## DRAFT REGULATORY GUIDE DG-1242

### SERVICE LEVEL I, II, AND III PROTECTIVE COATINGS APPLIED TO NUCLEAR POWER PLANTS

**Industry Comments on Draft Regulatory Guide DG-1242,  
"Service Level I, II, and III Protective Coatings Applied To Nuclear Power Plants."**

**STRATEGIC TEAMING AND RESOURCE SHARING (STARS)  
COMMENTS ON DRAFT REGULATORY GUIDE DG-1242,  
“SERVICE LEVEL I, II, AND III PROTECTIVE COATINGS  
APPLIED TO NUCLEAR POWER PLANTS”  
NRC Docket ID NRC-2010-0097**

**Figure 1. ASTM Standards Relevant to NPP Class I, II, and III Protective Coatings**

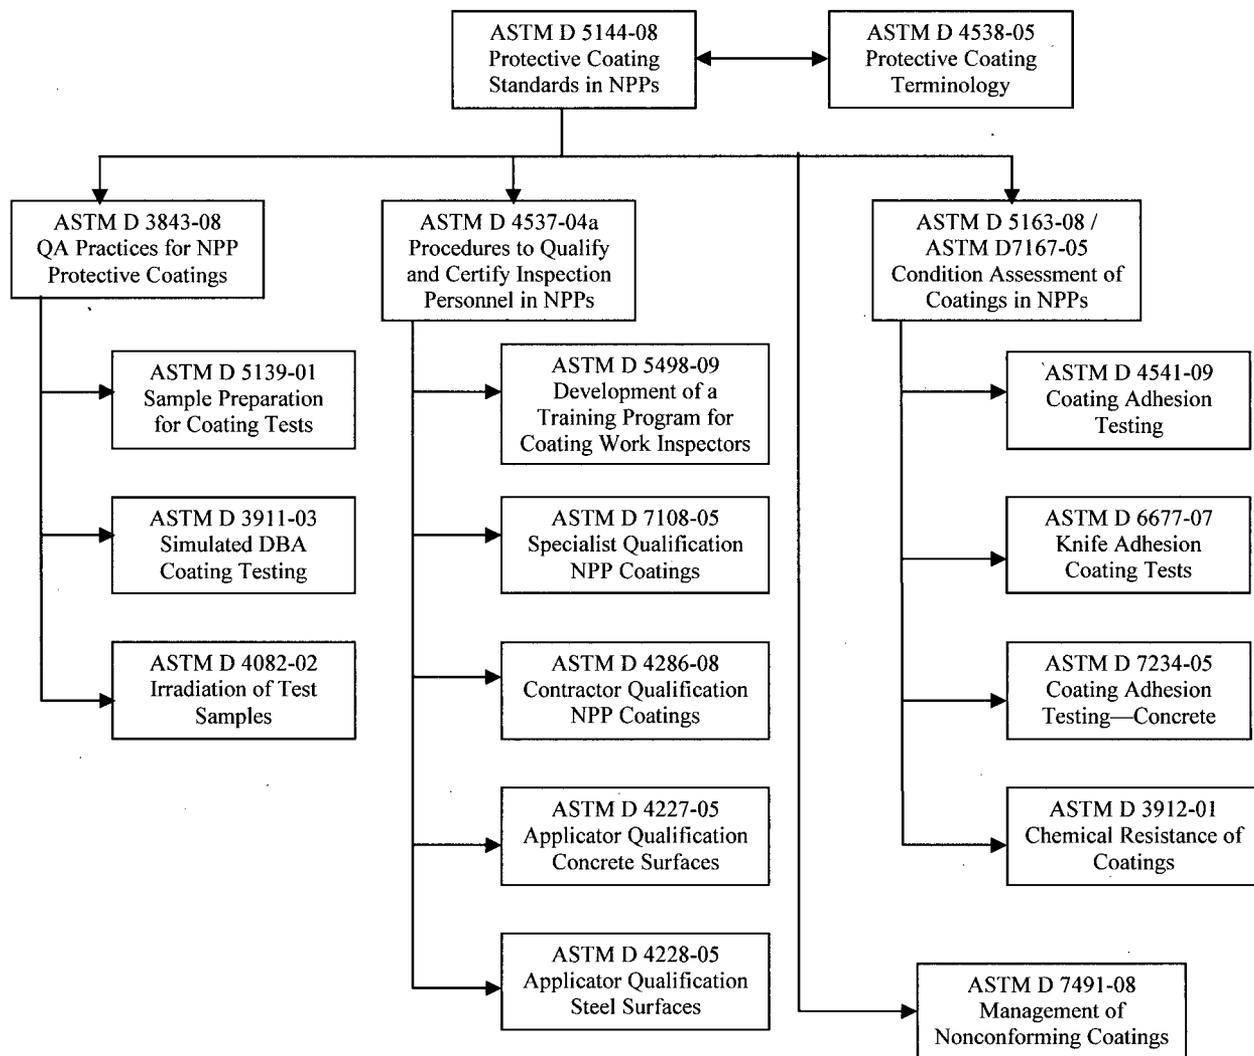
The following issues with ASTM International (ASTM) standards potentially impact Figure 1:

1. ASTM D3912-01 is used as a coating screening/qualification standard, not as a field coating assessment standard or tool.
2. ASTM D7108-05 is used as to qualify nuclear coating specialist for the coating program and coating assessment, not coating inspections.
3. ASTM D7491-08 is part of the coating condition assessment program.
4. ASTM D3911-03 has been revised to D3911-08.

Usage of ASTM D3912-95 (Reapproved 2001) is not consistent with Figure 1, which uses ASTM D3912-01.

Figure 1, ASTM Standards Relevant to NPP Class I, II, III Protective Coatings (Page 4):

Most ASTMs on this table are the same as the previous R.G. 1.54 Rev. 1. However, four were added and two were deleted. It is understood that ASTM D5962-96 was withdrawn with no replacement. Why was ASTM D 3359 (latest revision for this standard is ASTM D 3359-09) removed from the figure? Is this method of measuring adhesion not acceptable or is it covered under one of the new standards added?

**Figure 1. ASTM Standards Relevant to NNP Class I, II, and III Protective Coatings**

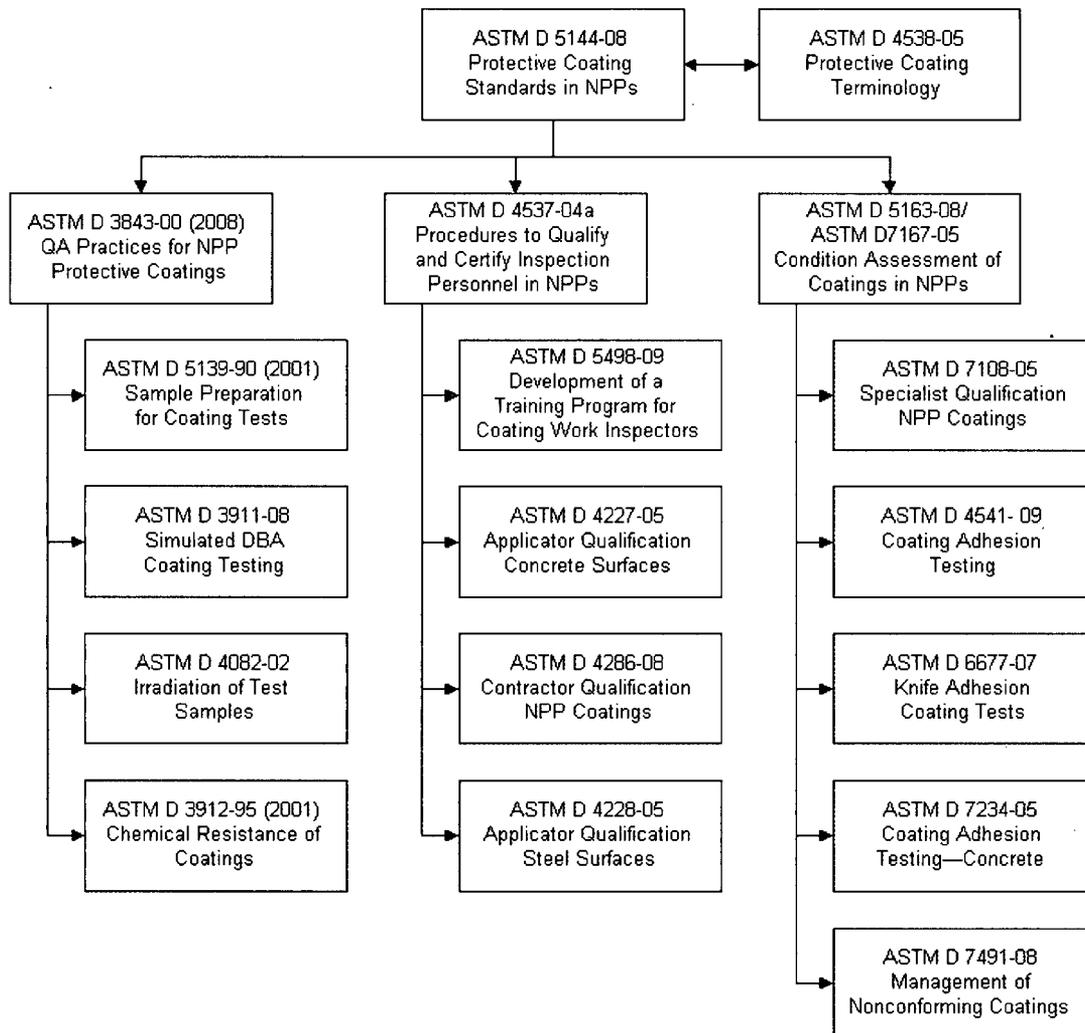
Recommend incorporating all of these issues into Figure 1, which results in the following:

Figure 1. ASTM Standards Relevant to NNP Class I, II, and III Protective Coatings

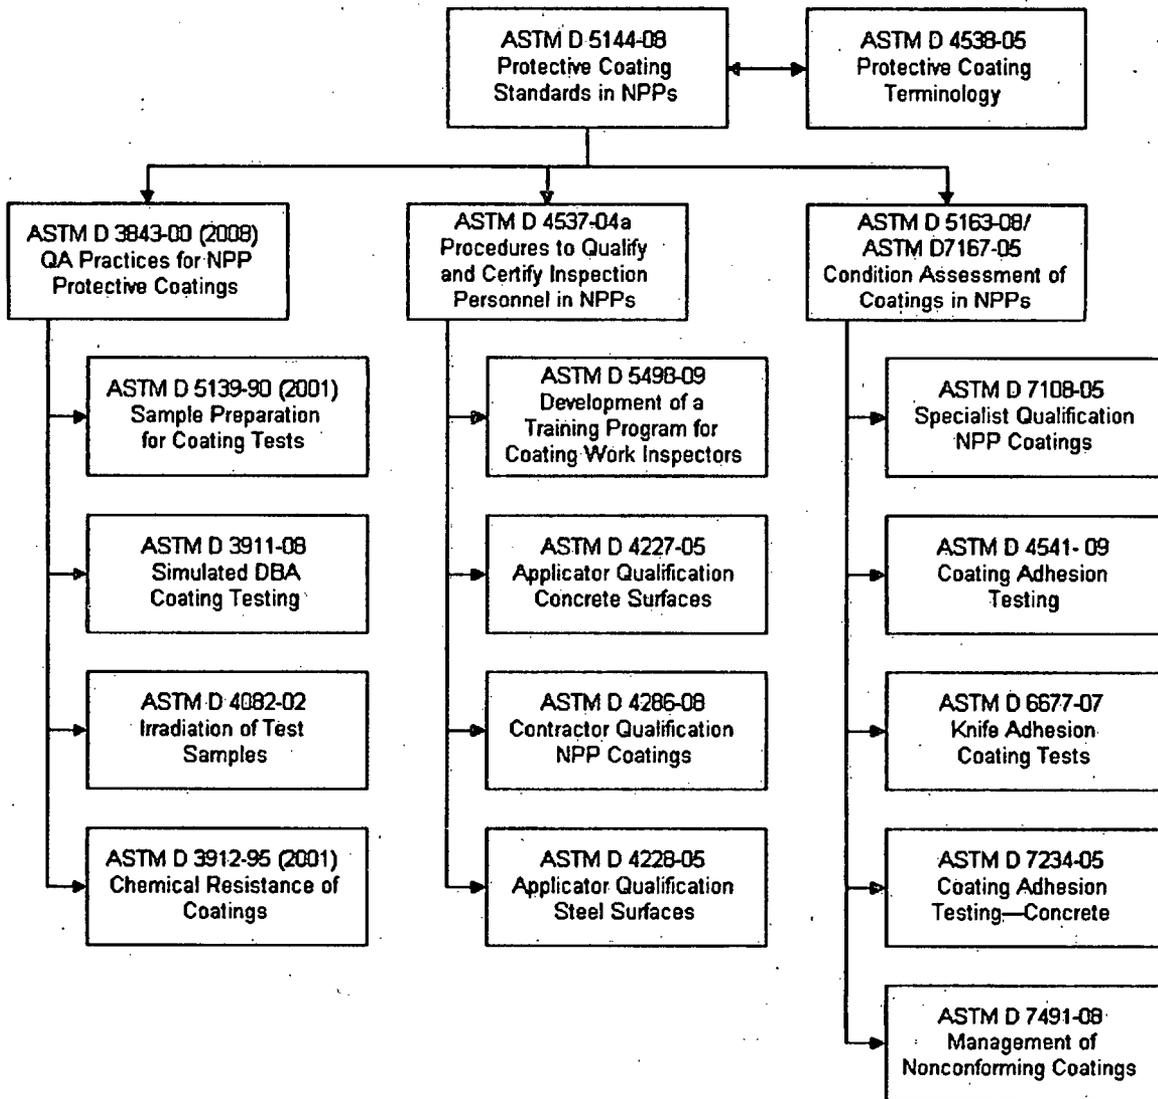
The following issues with ASTM International (ASTM) standards potentially impact Figure 1:

1. ASTM D3912-01 is used as a coating screening/qualification standard, not as a field coating assessment standard or tool. Also see Comment 4.
2. ASTM D7108-05 is used as to qualify nuclear coating specialist for the coating program and coating assessment, not coating inspections.
3. ASTM D7491-08 is part of the coating condition assessment program.
4. ASTM D3911-03 has been revised to D3911-08. Also see Comment 6.

Recommend incorporating all of these issues into Figure 1, which results in the following:

Usage of ASTM D3912-95 (Reapproved 2001) is not consistent with Figure 1, which uses ASTM D3912-01.
